11 November 2008

RE: HVO SOUTH COAL PROJECT – RESPONSE TO DWE SUBMISSIONS

The purpose of this letter is to address and consolidate CNA's submissions with respect to the issues raised by DWE in relation to the HVO South Coal Project Part 3A Application.

Figure 1
Approved HVO South Opencut Pits

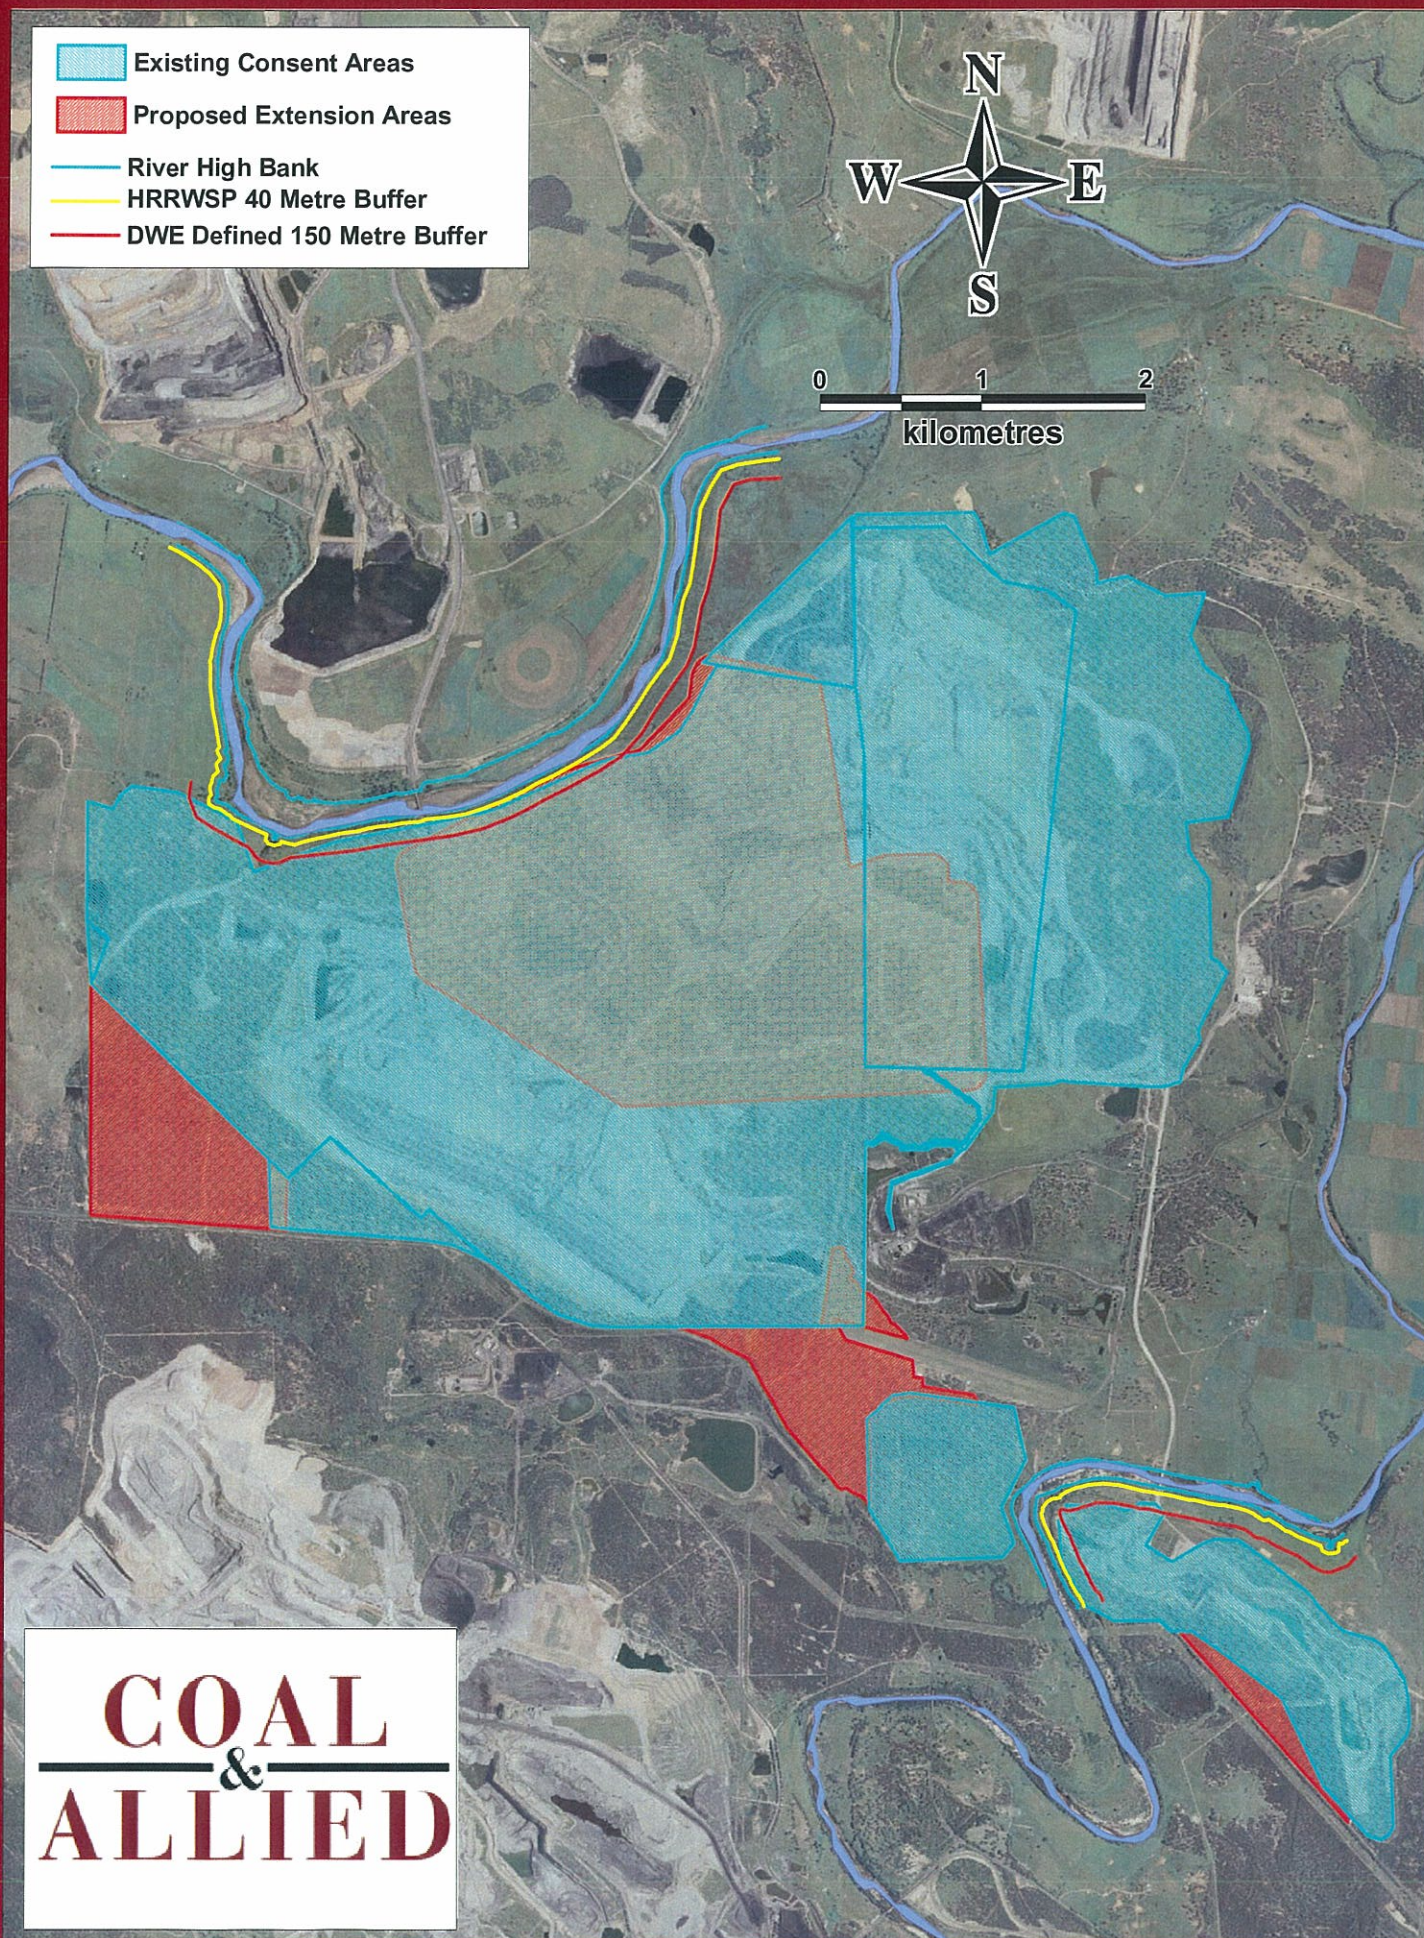
It is important to note that all the existing pits with the exception of the Cheshunt (Barry) Pit were consented prior to 2000. Figure 1 identifies these approved opencut pits. This figure also indicates the location of the 150m buffer zone.

Figure 2
HVO South Coal Project – proposed Extension Areas

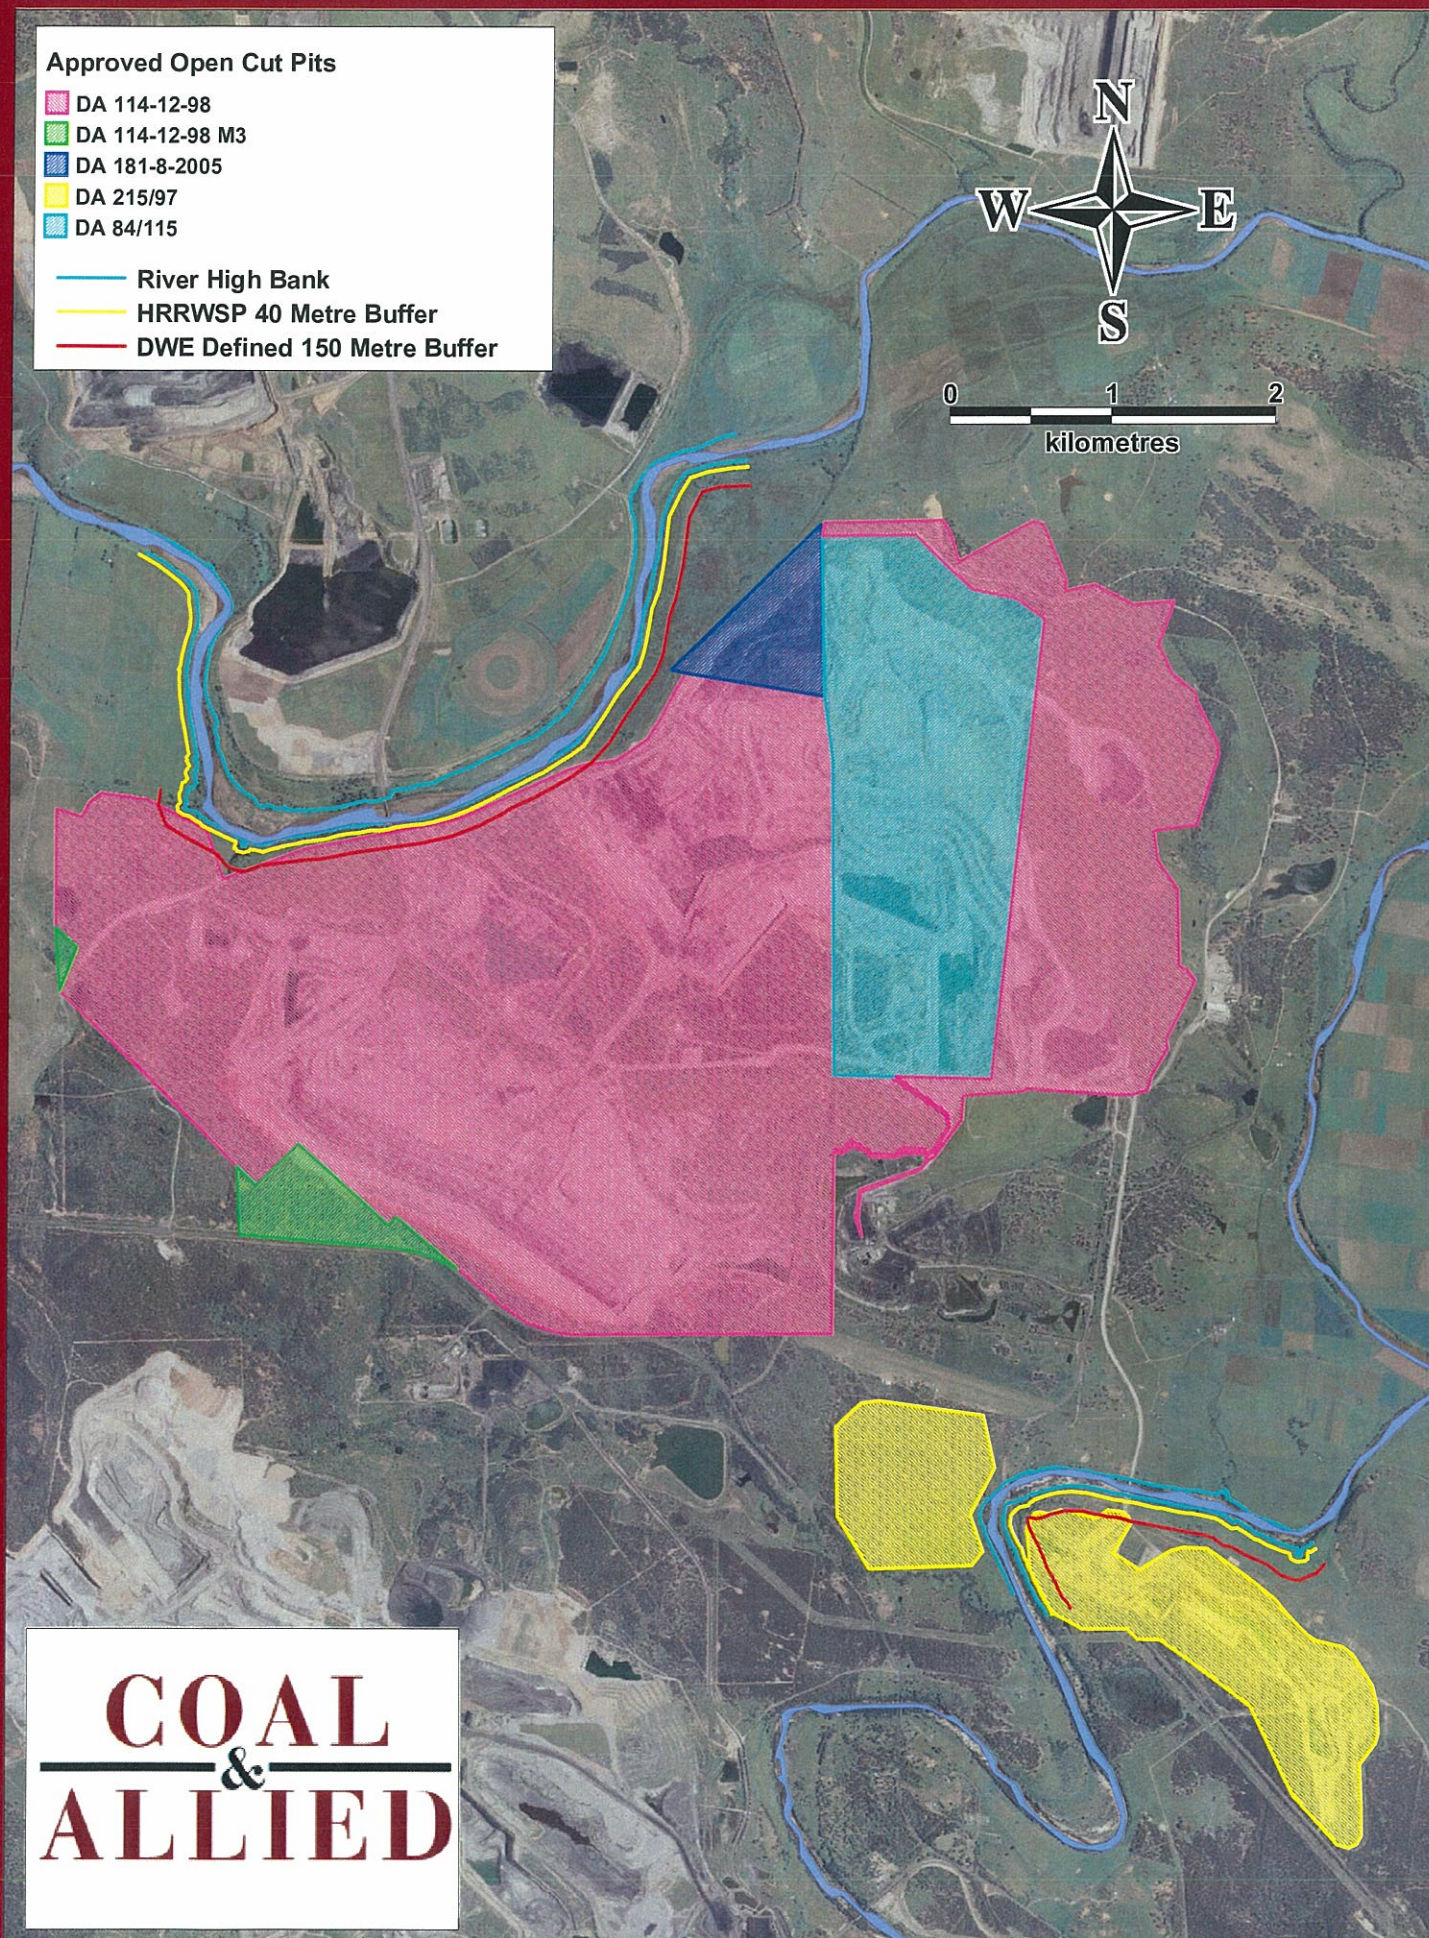
CNA recognises the application to the HRRWSP to our future mine expansions. The HVO South Coal Project seeks approval for extensions to the Cheshunt, Riverview Pits and South Lemington Pit 1. Refer to Figure 2 for the proposed extension areas. These extensions will be considered in respect to the HRRWSP. CNA seek to work with DWE to achieve outcomes that are consistent with this plan.
